OUR REF: 476088 - 01000

Re: **1354 Carling Avenue CTS/TIS**
Addendum #1

The Community Transportation Study/Transportation Impact Study (CTS/TIS) for the proposed residential development located at 1354 Carling Avenue was submitted in April 2017. Comments have been received on the CTS/TIS from the City of Ottawa and the Site Plan for Phases 1 and 2 has been revised and is attached (Attachment #1). This Addendum #1 has been prepared to address the comments received and address the transportation related changes to the proposed Site Plan, which include:

Figure 1: Updated Transit Map

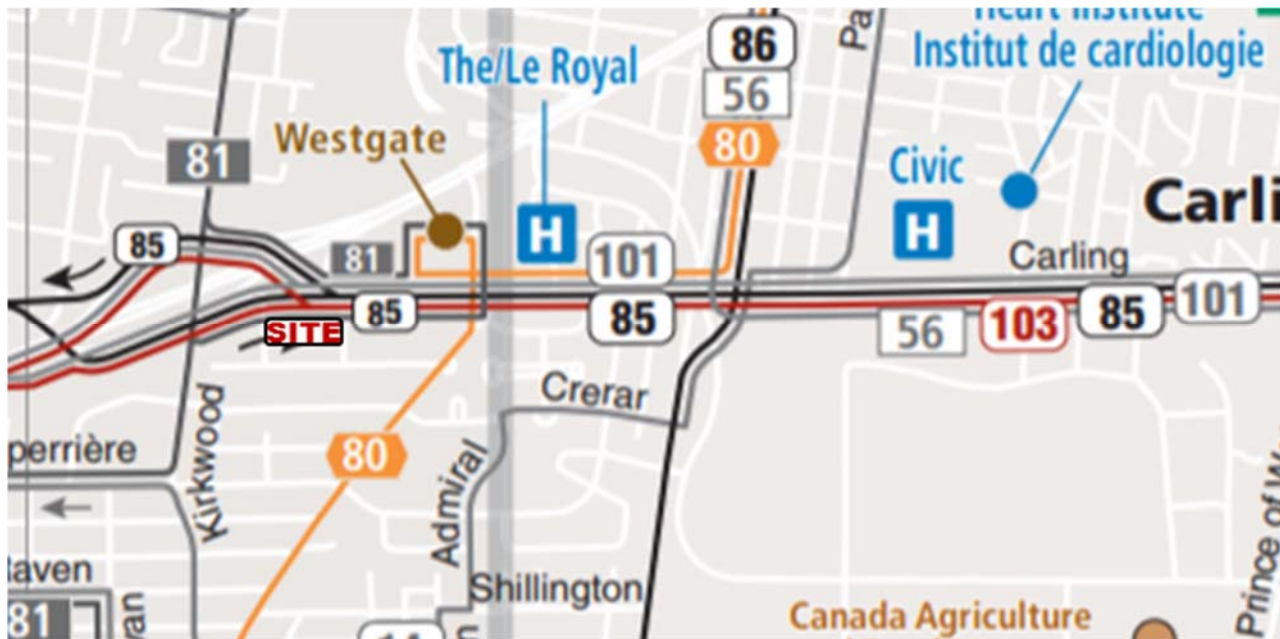
Comment 2.4: The April service change saw route 151 renumbered to 81. The transit network exhibit in this section is out of date. Several other routes illustrated have had their number changed: e.g. 6 to 56, 176 to 80, and 150 to 80.

Response 2.4: Noted, the revised transit map is shown as Figure 1.

Figure 2: Existing Peak Hour Traffic Volumes

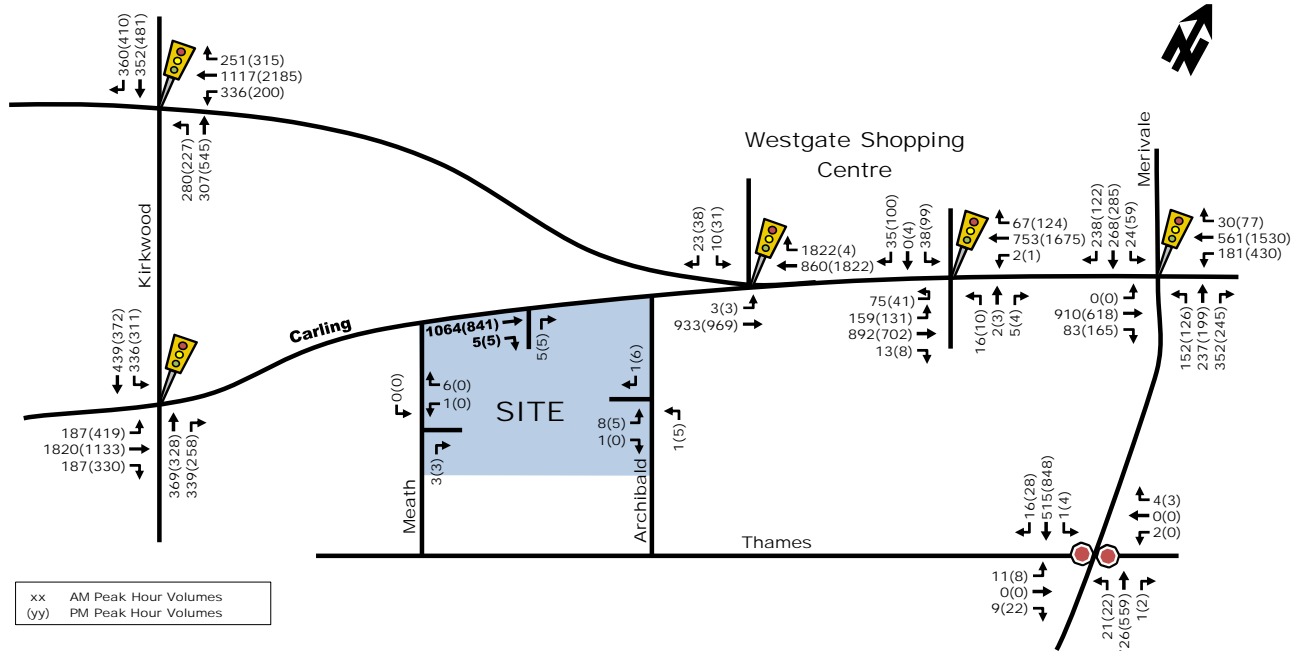
Comment 2.17: *The signal west of Carling Avenue and Westgate must be included in the analysis.*

Response 2.17: Noted. The revised existing conditions for the Carling/73 m East of Archibald signal are summarized below.

Figure 4: Possible Bulb-Out Option along Archibald and Meath

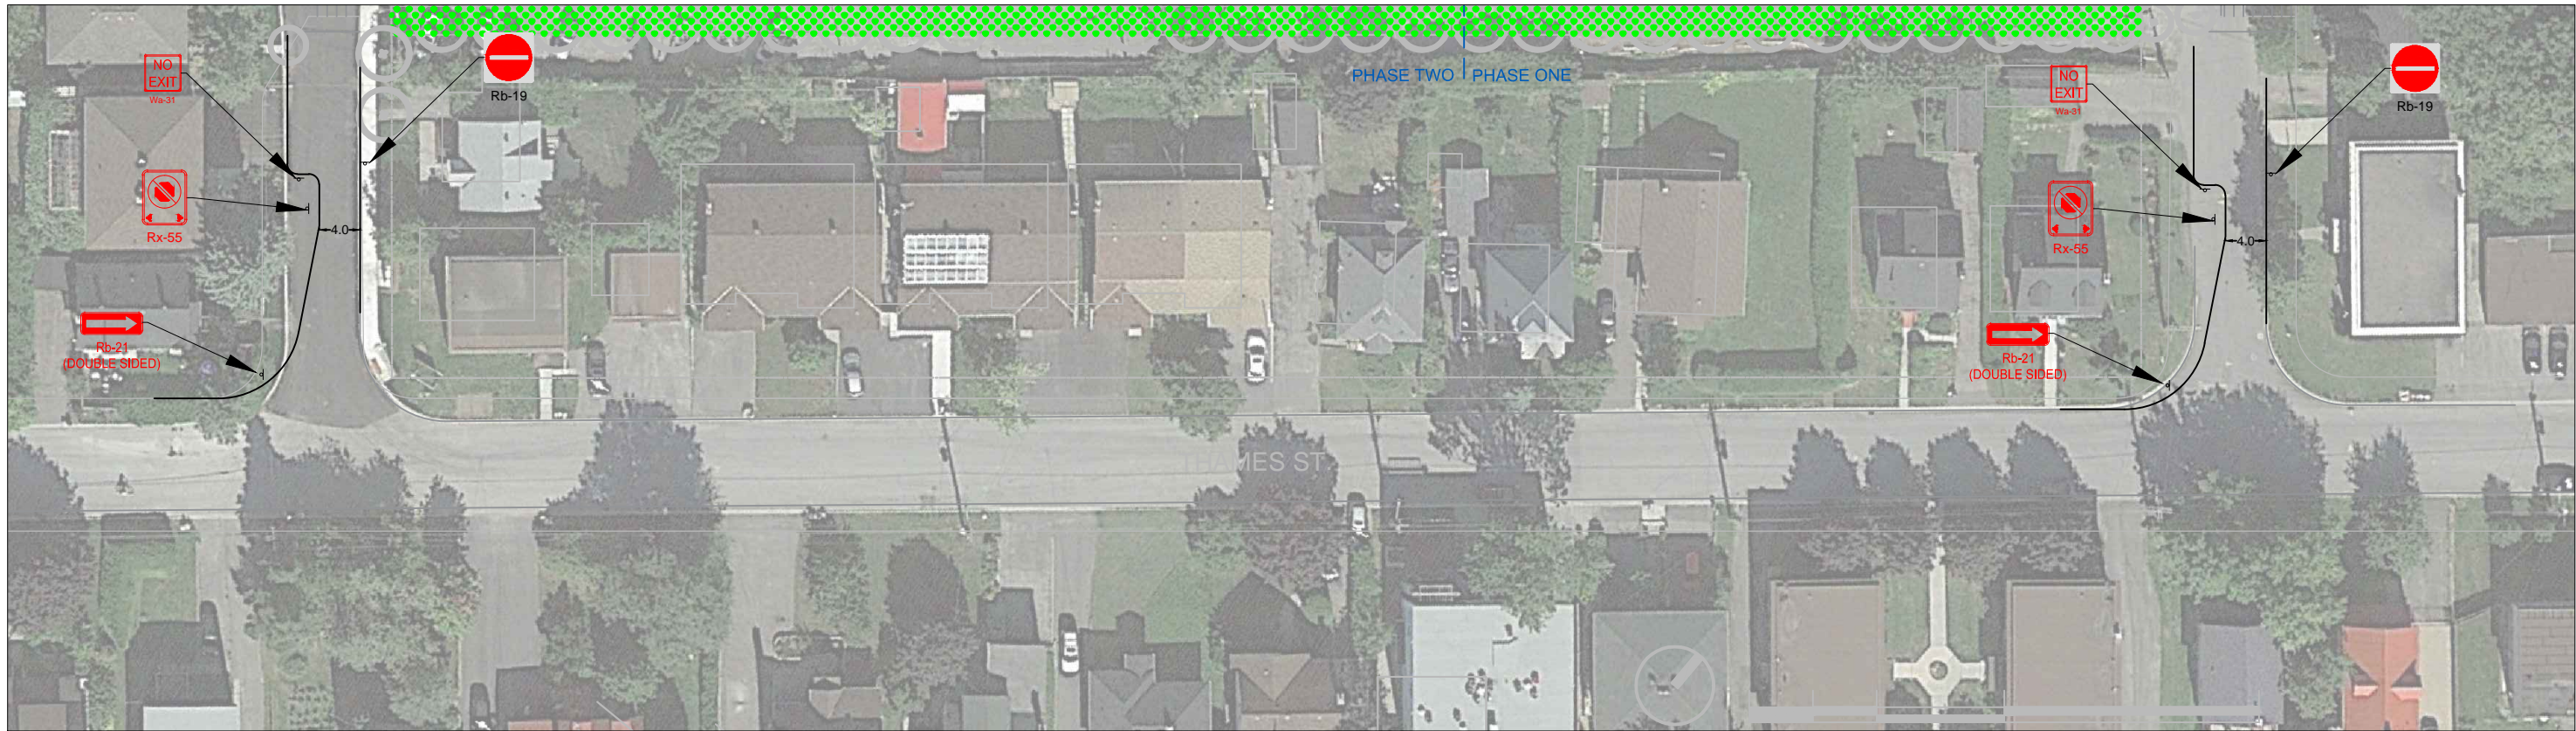
Comment 2.22: *Modifications to Meath Street and Archibald Street may be required to control movements from the site. Provide a road plan showing the location of the existing accesses on both sides of these streets.*

Response 2.22: The options for improvements to the bulb outs on Archibald Street and Meath Street were also assessed as part of the Technical Memorandum prepared in March. The following Figure 4 shows a proposed options to help enforce the one-way operation of Meath Street and Archibald Street at their intersections with Thames Street. As shown there are private driveways just north of each of the proposed bulb-outs.

Proposed Closure of Meath Street Drawing

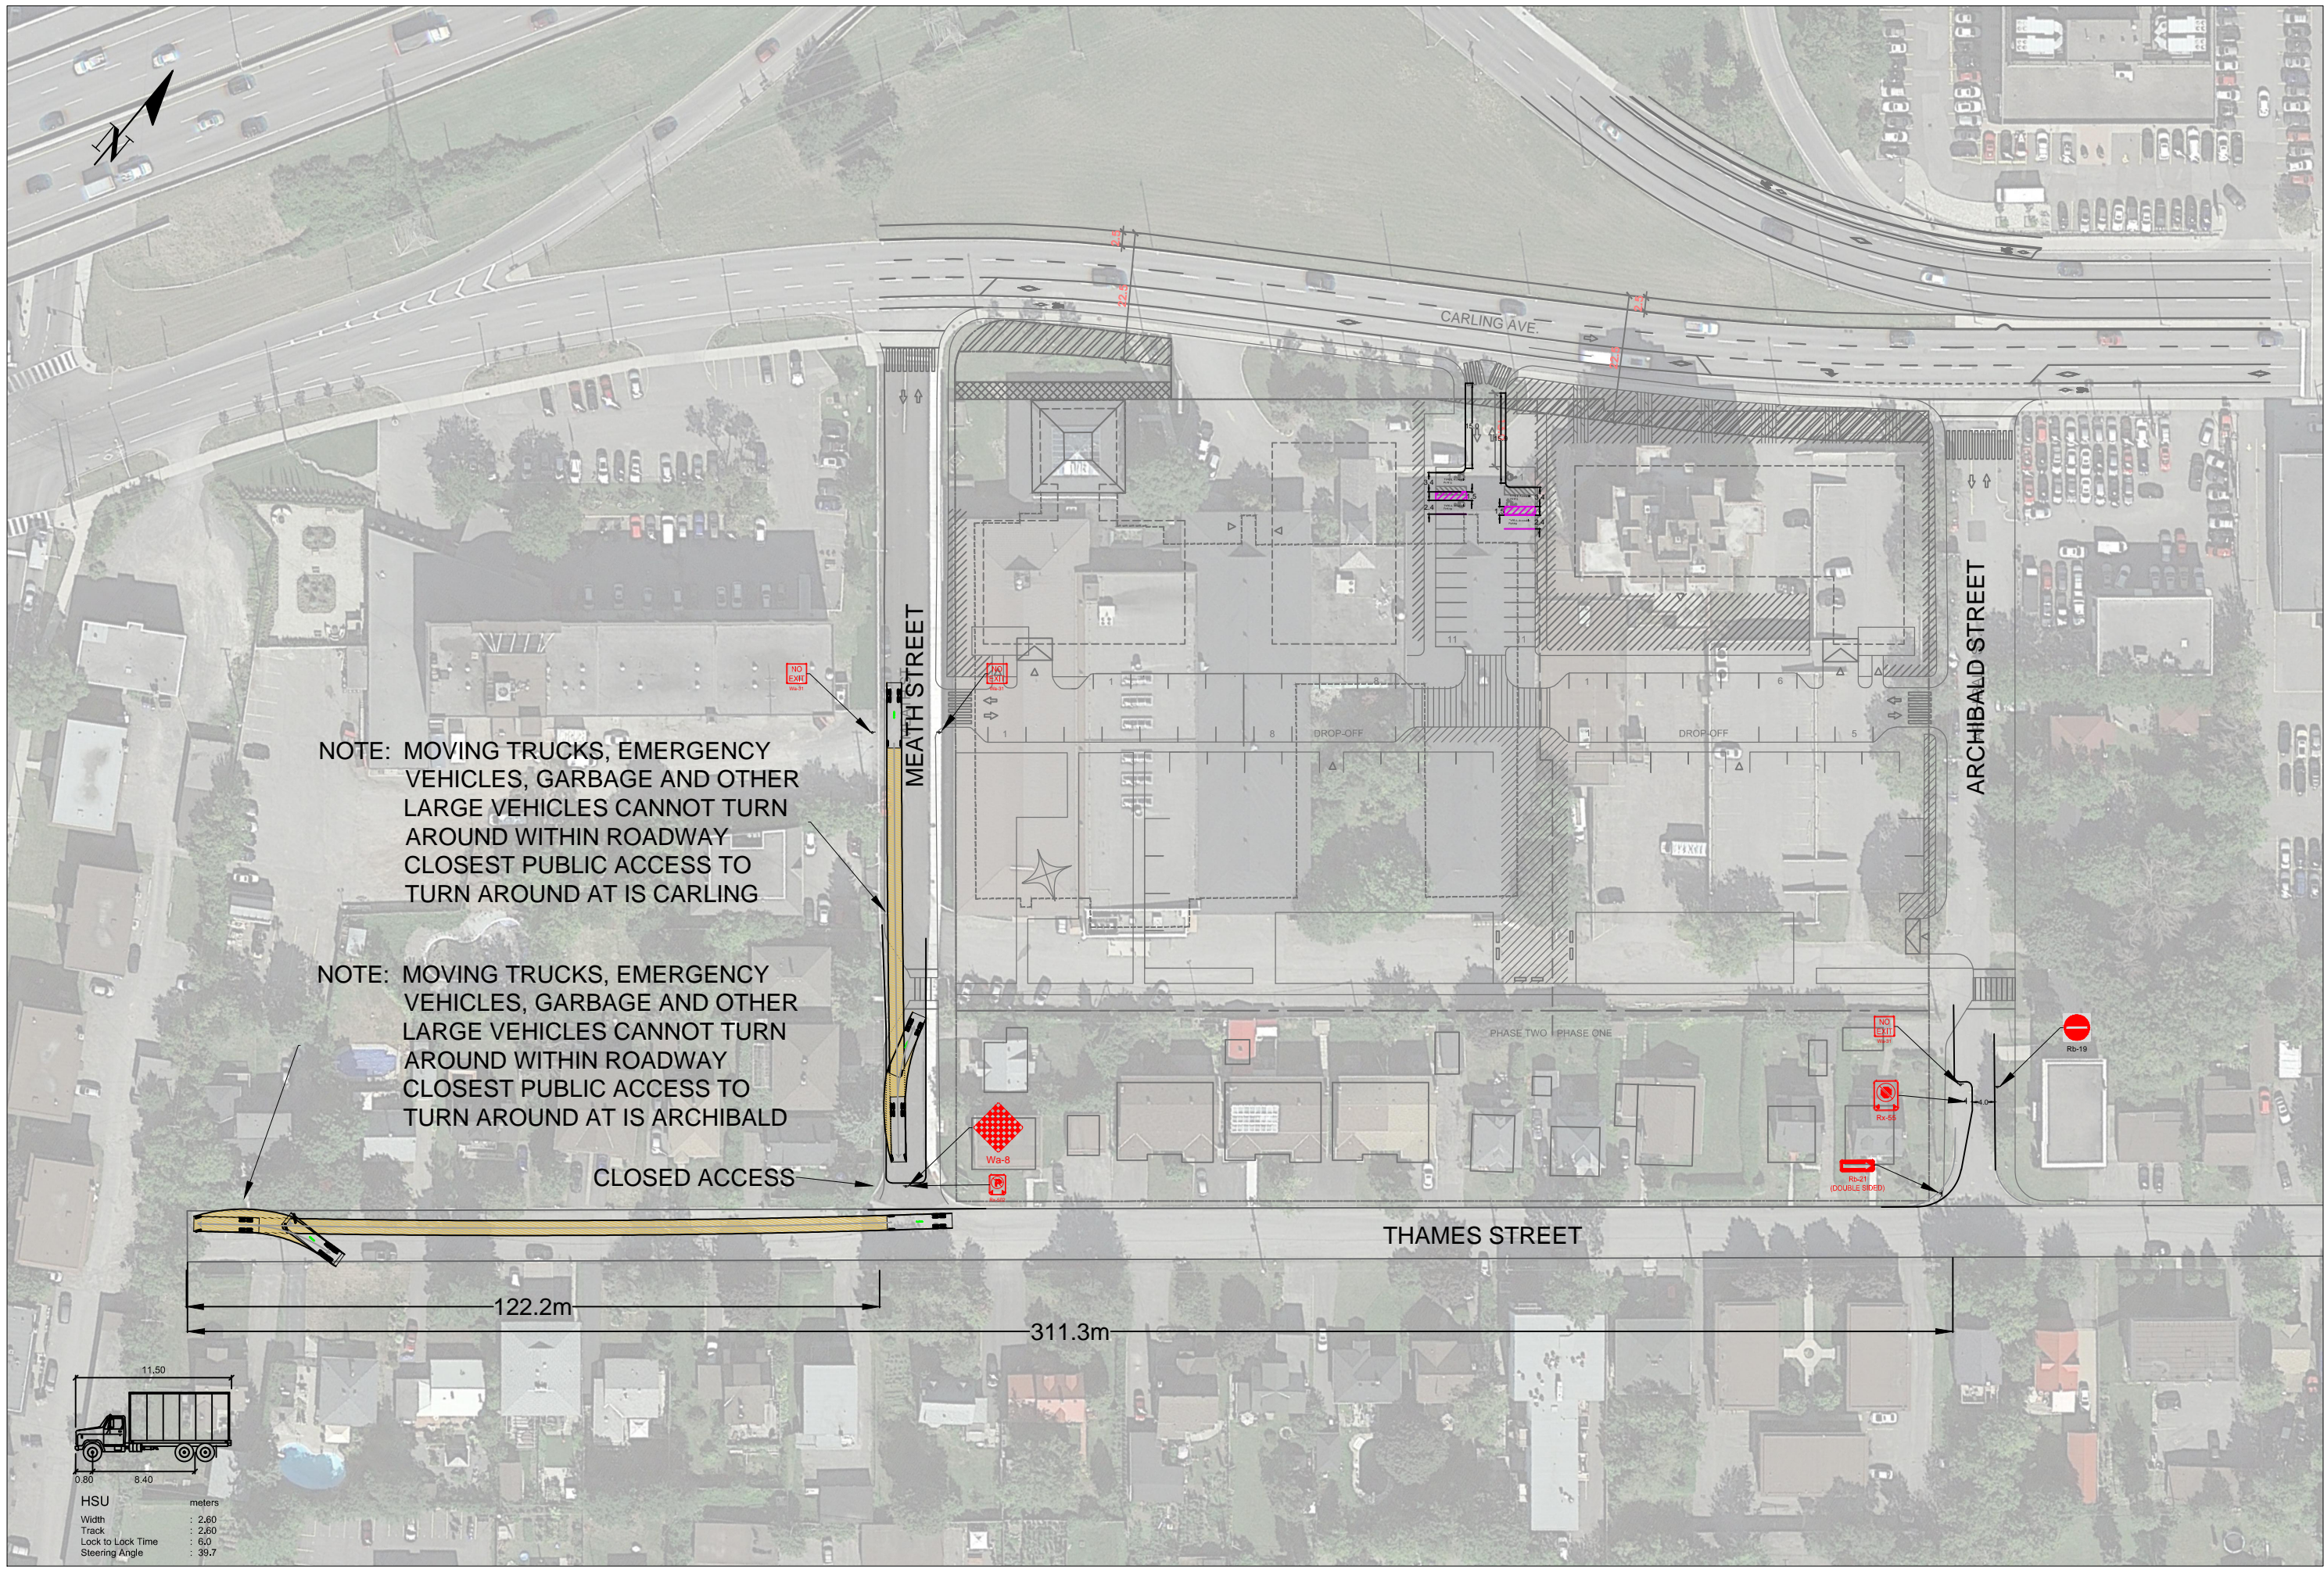
Comment 2.21: The use of Thames Street as a west-bound access is an issue, and Carling Avenue options need to be reviewed. Please address cut-through traffic in your revised CTS. Any option looking at a west-bound Carling Avenue left-turn lane would require an RMA and discussions with MTO and City Staff.

This topic is further discussed in the attached Technical Memorandum, which was prepared by Parsons in March 2018 (Attachment #2). A meeting was organized with the local City Councillor and it was proposed that Meath Street would be closed and a narrowing along Archibald Street would be implemented at the one-way location (using a bulb-out). This is shown in the attached drawing (Attachment #3). There are several concerns from a transportation perspective with this option:

- 1) Existing 'cut-through' traffic using Meath Street will likely continue to 'cut-through' the neighbourhood using Archibald Street instead;
- 2) Trucks at the Meath Street dead-end have no public turn-around location. An agreement to use the subject site's driveway connection to Meath Street would be required, otherwise, trucks would be required to reverse to Carling Avenue and back up onto Carling Avenue to turn around; and
- 3) Trucks at the Thames Street dead-end currently reverse approximately 120 m to turn around using Meath Street. With the closure of Meath Street, trucks will have to reverse 300 m to Archibald Street to turn around.

Based on the foregoing, the closure of Meath Street is not recommended from a transportation perspective, as it will not prevent cut-through traffic through the neighbourhood and will cause issues with truck movements in the area. The narrowing of both Meath Street and Archibald Street using bulb-outs, as outlined in the attached memo, is recommended. However, it is understood that through consultation with the local Councillor and community, the planning department may elect to close Meath and develop a channelized one-way lane at Archibald, to which the proponent is agreeable.
